DOCKET 05-BSTD-2
DATE JUL 12 2006
RECD. SEP 27 2006

Comments on Title 24 Residential Lighting

By: Noah Horowitz
Sr. Scientist
Natural Resources Defense Council
nhorowitz@nrdc.org

June 2006

Current Title 24 Res. Lighting Code

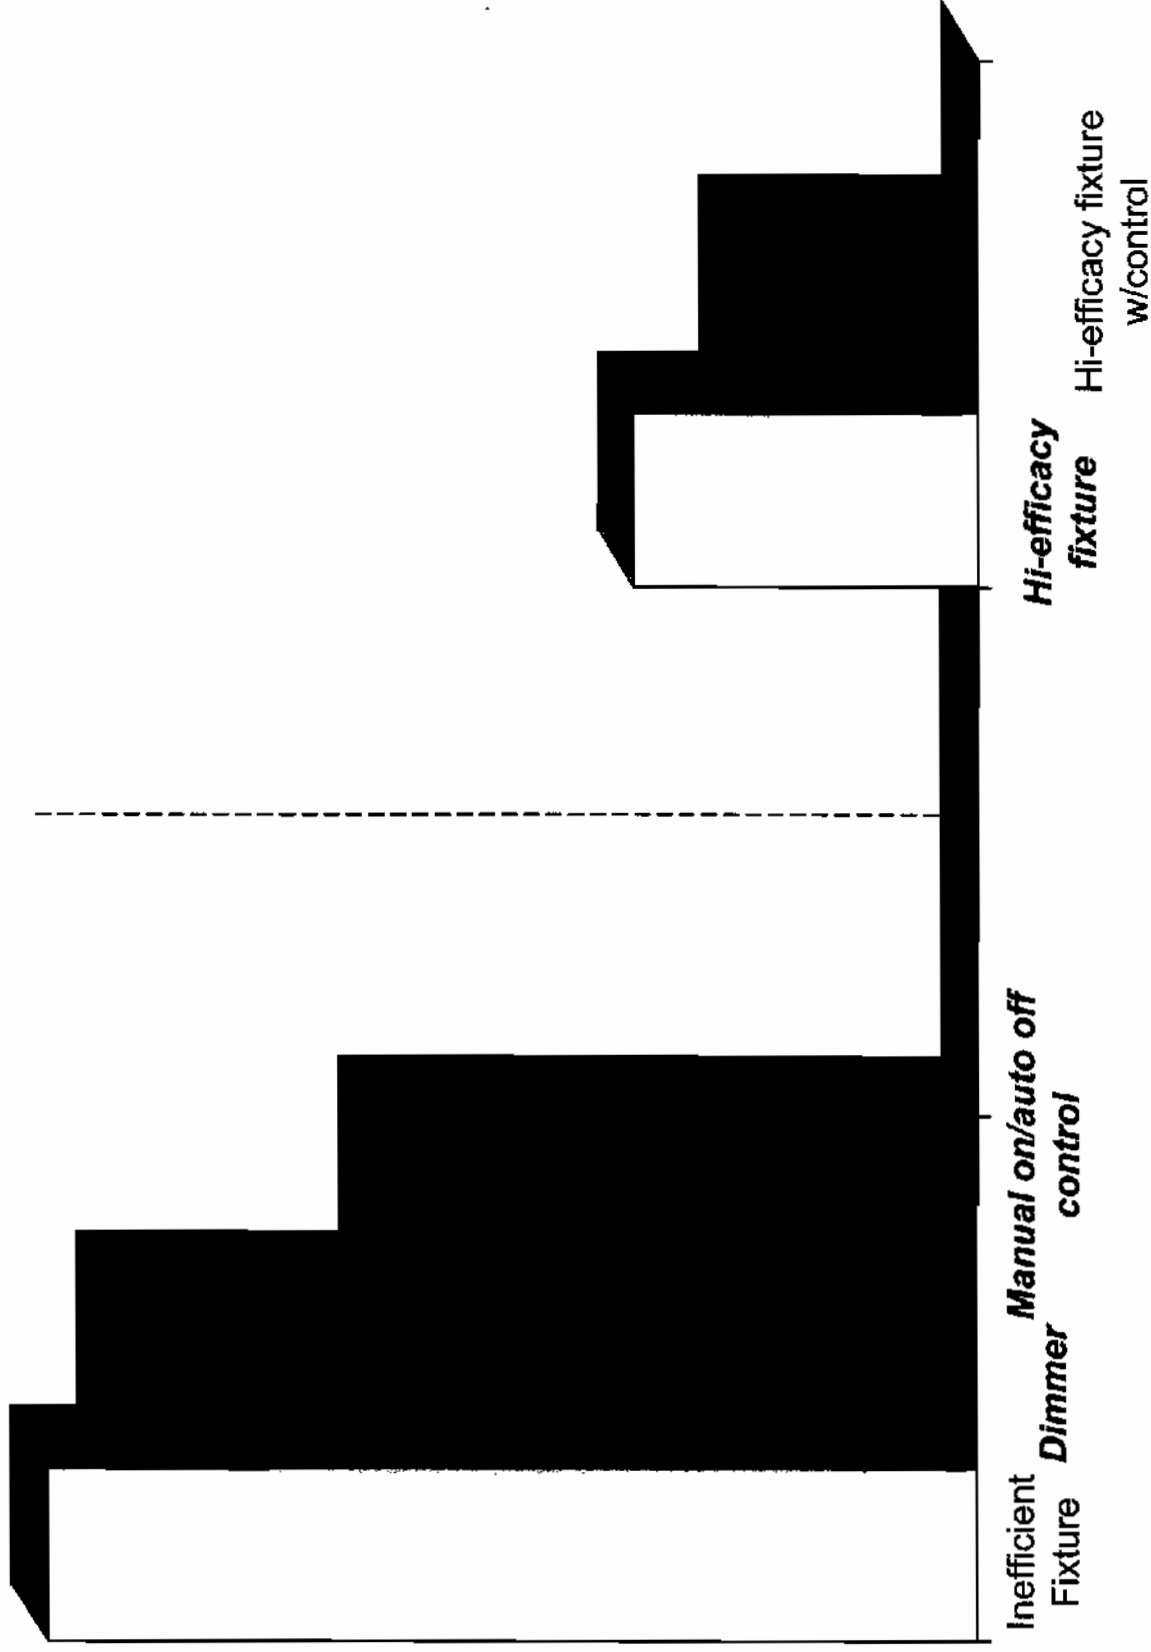
As dimmer is much lower cost option, it will be used most frequently.

Concerns About Installing An Inefficient Fixture and Dimming It

- Dimming seldom used. Results in very little savings compared to occupancy sensor or hi-efficacy fixture.
- “Regular” screw-based CFLs not compatible with dimmers. Will result in shorter CFL life and bad consumer experience.
- Potential Nightmare – will turn consumer off from screw-based CFLs in other sockets and huge lost savings opportunities.

- Proposed Section 10 allows dimmers as compliance path for bedroom, living room, hallway, stairway, den, family room, etc.
 - **Option A - Remove dimming option for bedroom and hallways. Wide range of efficient luminaires available for these applications.**
 - Bedroom savings (assume base case of 2 sockets with 75 W lamps vs. 2 @ 18 W), up to 170 kWh/yr per bedroom
